**ADDENDUM NO. 1  
CITY OF PEORIA  
Wisconsin Avenue Roadway Improvements Nebraska to McClure  
February 5, 2024**

Re: Addendum for Bid Package, **Wisconsin Avenue Roadway Improvements**, Peoria, IL

This Addendum modifies the quantity of proposed relocations of light fixtures, includes additional details and notes for lighting and foundation construction, and modifies the quantity of wiring for the relocated lights. This Addendum also includes an electronic pay item spreadsheet for use in preparation of bid documents.

**WISCONSIN AVENUE NEBRASKA TO MCCLURE SCHEDULES**

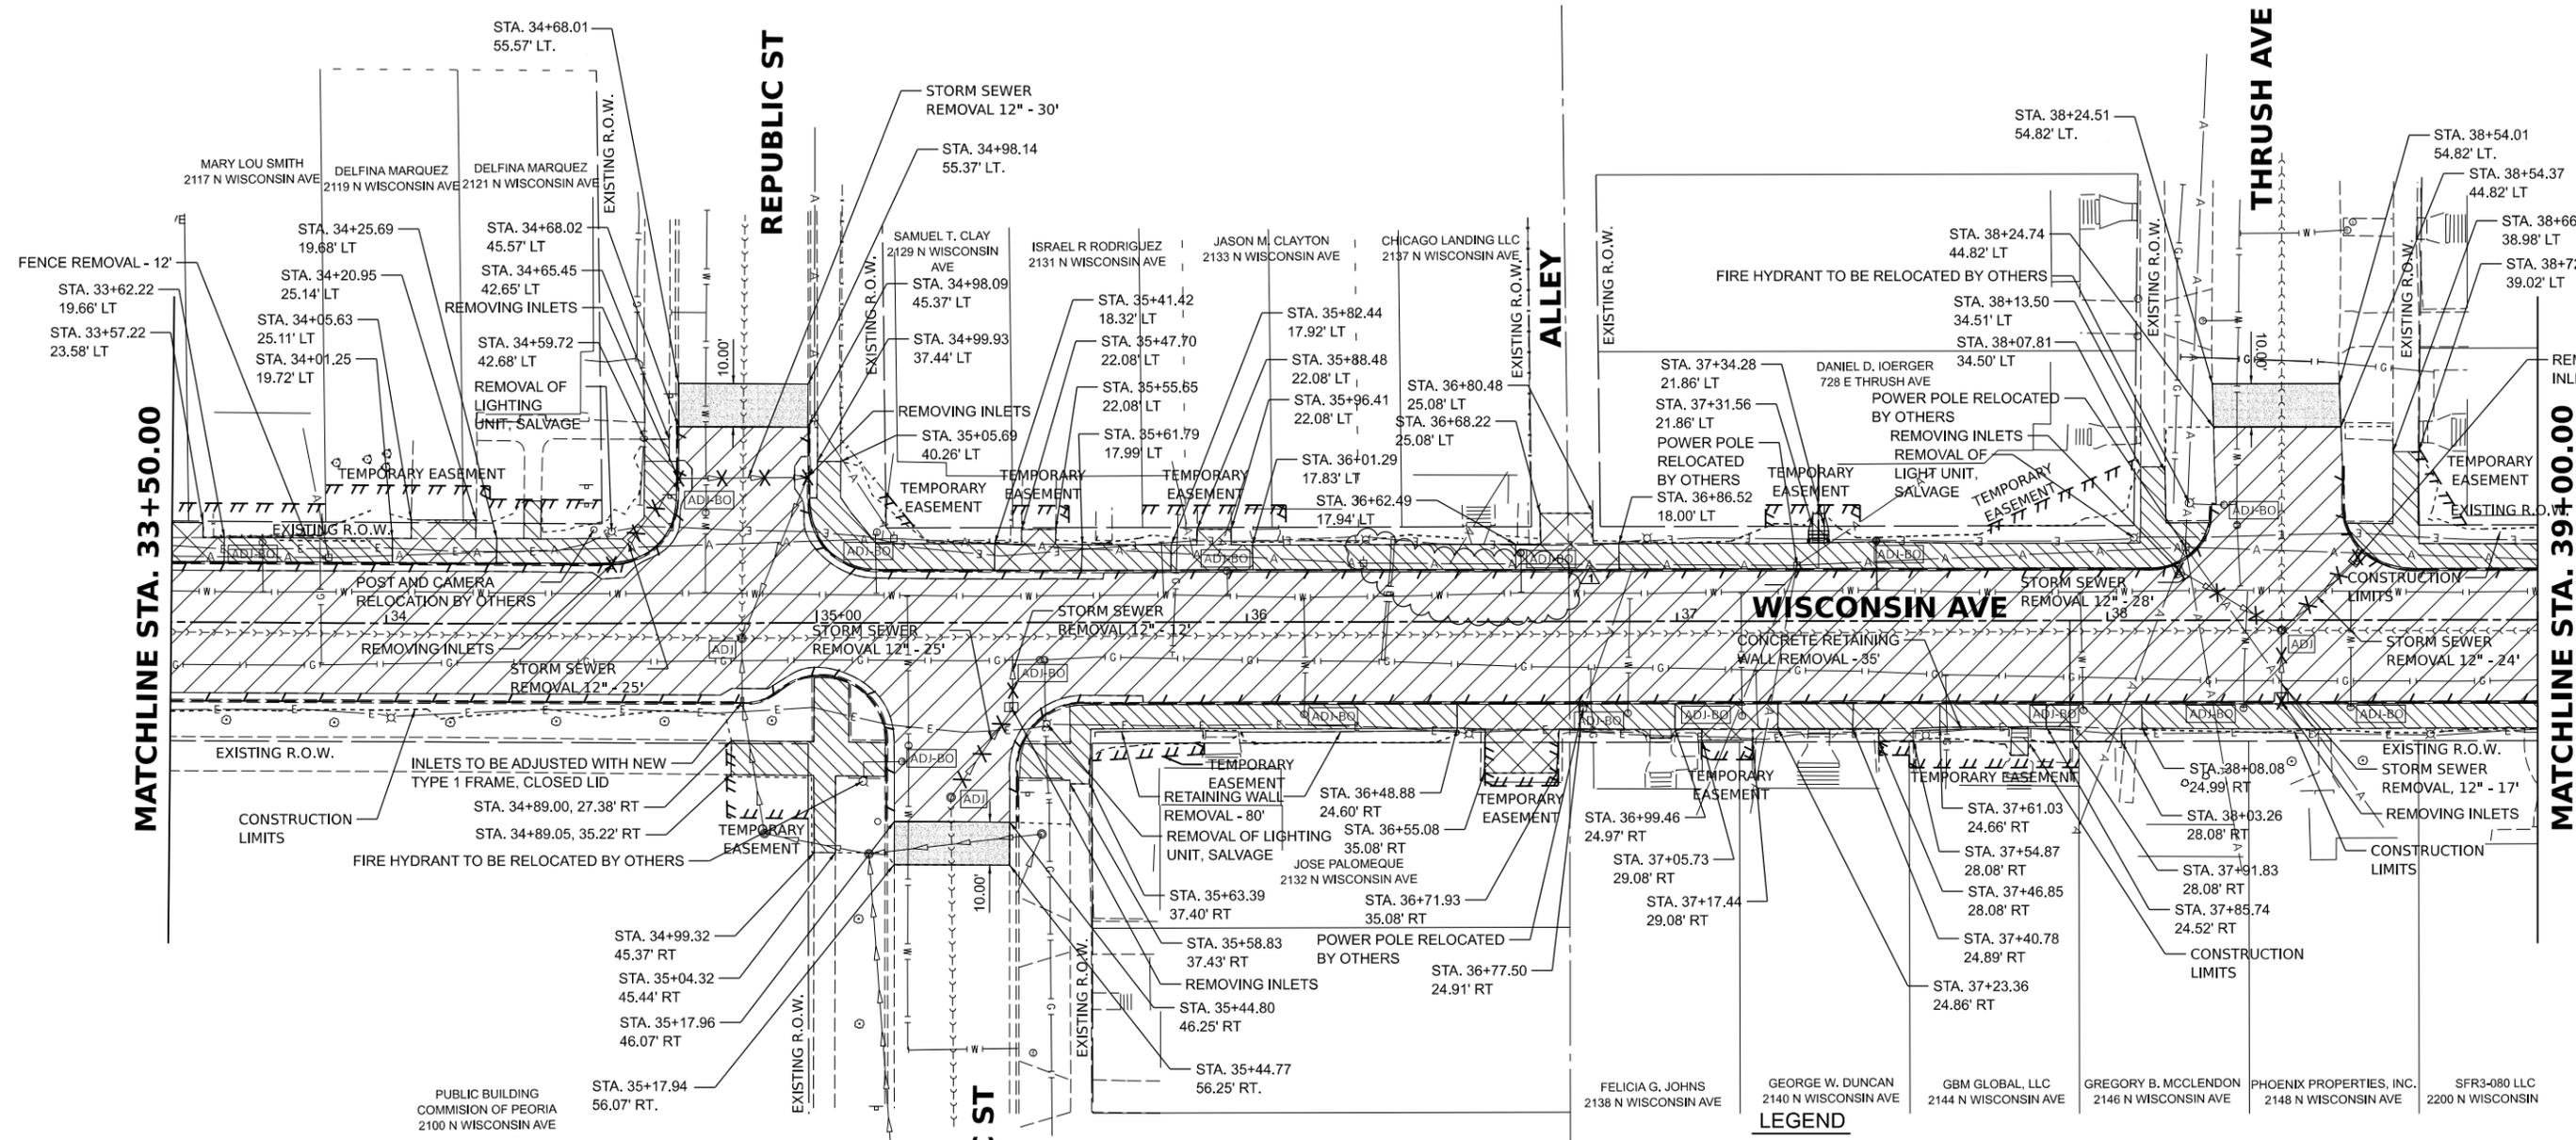
3. Revise bid quantities for the following items:
  - a. 81028350 UNDRGRD C PVC 2
  - b. 81702110 EC C XLP USE 1C 10
  - c. 83600200 LIGHT POLE FDN 24D
  - d. 84200500 REM LT UNIT SALV

LIGHTING REMOVAL SCHEDULE		
LOCATION	84200500 REMOVAL OF LIGHTING UNIT, SALVAGE	
STATION	OFFSET	EACH
WISCONSIN AVENUE		
27+37.87	17.52' LT	1
34+52.41	21.29' LT	1
35+53.48	23.21' RT	1
38+06.20	19.18' LT	1
40+20.26	18.69' LT	1
41+29.91	19.66' LT	1
48+89.36	25.57' RT	1
48+97.20	18.95' LT	1
49+77.60	27.73' LT	1
TOTAL		9

LIGHTING SCHEDULE		
LOCATION	83600200 LIGHT POLE FOUNDATION, 24" DIAMETER	
STATION	OFFSET	FOOT
WISCONSIN AVENUE		
27+38.06	21.22' LT	3
34+51.45	24.60' LT	3
35+51.76	30.06' RT	3
37+98.06	20.88' LT	3
40+20.32	19.45' LT	3
41+26.18	20.88' LT	3
48+89.43	26.74' RT	3
48+97.30	19.29' LT	3
49+70.21	24.13' LT	3
TOTAL		27

ELECTRIC CABLE SCHEDULE					
LOCATION		81028350 UNDERGROUND CONDUIT, PVC, 2" DIA.	81702110 ELECTRIC CABLE IN CONDUIT, 600V (XLP-TYPE USE) 1/2" NO. 10		
WISCONSIN AVENUE		FOOT	FOOT		
BEGIN STATION	BEGIN OFFSET	END STATION	END OFFSET		
25+89.42	24.44' LT	27+38.06	21.22' LT	25	522
27+38.06	21.22' LT	28+58.45	24.19' LT	25	435
33+45.86	21.31' LT	34+51.45	24.60' LT	25	390
34+01.24	21.84' RT	35+51.76	30.06' RT	25	528
34+51.45	24.60' LT	36+27.92	19.38' LT	25	531
35+51.76	30.06' RT	36+51.41	26.47' RT	25	375
36+93.06	19.28' LT	37+98.06	20.88' LT	25	390
37+98.06	20.88' LT	40+20.32	19.45' LT	25	666
40+20.32	19.45' LT	41+26.18	20.88' LT	25	318
41+26.18	20.88' LT	42+74.53	19.38' LT	25	519
47+75.73	26.22' RT	48+89.43	26.74' RT	25	417
48+11.01	19.91' LT	48+97.30	19.29' LT	25	258
48+70.21	24.13' LT			50	1500
TOTAL				350	6849
